Revised Final Plan
Attachment 9.12

Turbine Exhaust Replacement

Dampier Bunbury
Pipeline

1.2 DBP's response to the Draft Decision

Figure 1.1: Program schedule

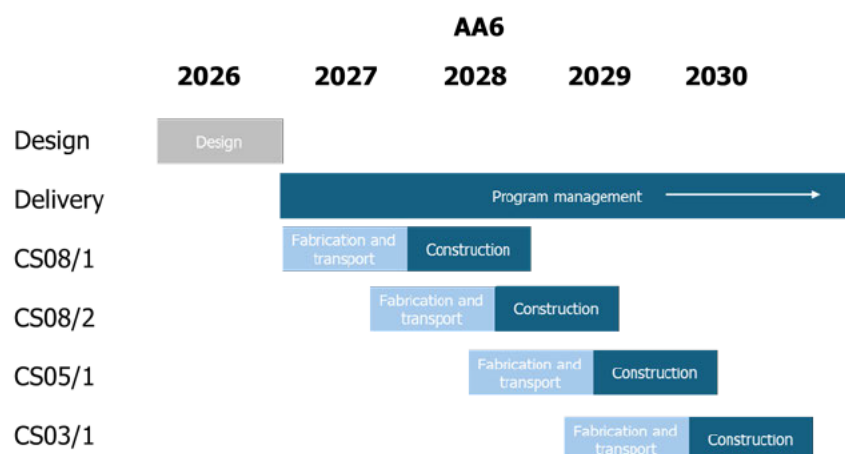
Our proposed delivery approach front ends the design of the replacement exhausts (all are ACS units leveraging the same design), with the delivery of each unit staggered thereafter as shown in the following diagram.

As shown in the figure above, we have not yet completed the design for the ACS unit exhaust replacements. This will be conducted during 2026. As such, we have based our estimate of the costs on the most recent unit replacement, the [REDACTED]. We consider this approach meets the requirements of NGR 74 as it has been arrived at on a reasonable basis (i.e. using the most recent similar project) and represents our best estimate in the absence of the design work being complete.
